NEW NUTS PROTECT LUGS

Stop using NSN 5310-00-241-6664 to order new, self-locking roadwheel nuts for your M2/M3-series Bradley and MLRS carrier.

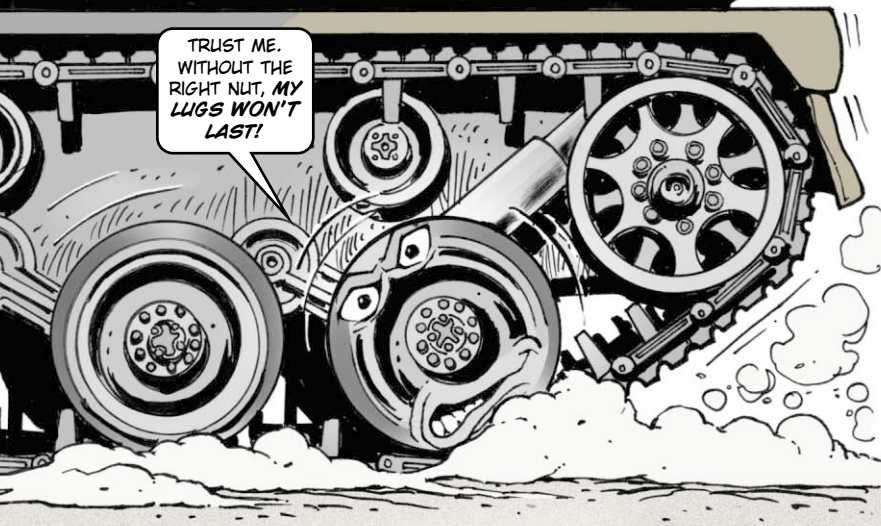
That NSN brings one of two different style nuts. The first, which has a nylon insert, is OK. The second, however, uses crimped steel threads for locking. The crimped nut chews up the threads on the roadwheel lugs.

To get only the nuts with the nylon insert, use NSN 5310-00-175-2710. Make a note until the parts manuals are updated.
